# DCS Technical Team Repair/Installation Request

<b>1.</b>	<b>Location(s)</b>	<b>Control #</b>
	Lomita Sheriff DCS Room and Antennas 26123 S. Narbonne Avenue, Lomita CA 90717	LMT-01 rev3
<b>2.</b>	<b>Statement of the Problem(s)</b>	
	<p>A. Position #1: 2m antenna has phase distortion and intermodulation on simplex signals and varying SWR probably due to visible contact with tree limbs and vines. Antenna seems to have one of the three radials missing.</p> <p>B. Position #2: 2m antenna has poor performance at the top of the 2m amateur band (WA6ZTR input freq); SWR 1.2 @ 144 MHz; 1.25 @ 145 MHz; 1:40 @ 146 MHz; 2.0 @ 147.5 MHz; 2.4 @ 147.87 MHz. Antenna seems to have one of the three radials missing.</p> <p>C. Position #4a: IC-726 HF radio, LA Co. tag 55068 (the primary 6m radio) with 6m/10m dual band antenna exhibits poor performance. On 6m SWR is 1.7 but exhibits 60dB over 9 noise level @ 50.62MHz and the output power is 4 watts. On 10m SWR is 3.1 @ 29.63 MHz.</p> <p>D. Position #4b: IC-726 HF radio, LA Co. tag 55080 (the primary 10m radio) with the vertical wire HF Antenna and tuner is poor on 10-meters: SWR 5.1 @ 29.63 MHz.</p> <p>E. Lomita cannot support NVIS.</p>

## HF Position

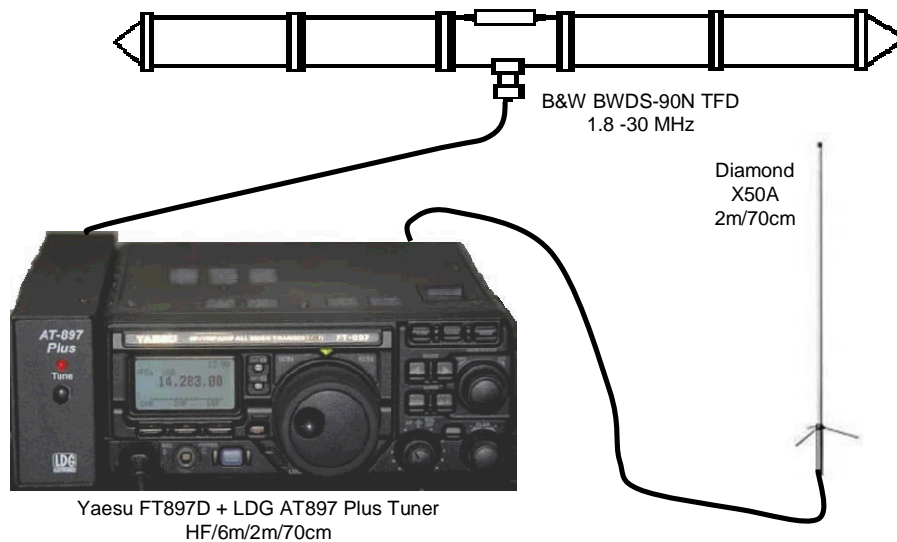
- HF bands with horizontal polarization to support NVIS
- Second antenna port for 2m/70cm dual band antenna
- Radio in stock, but not the tuner or other antennas
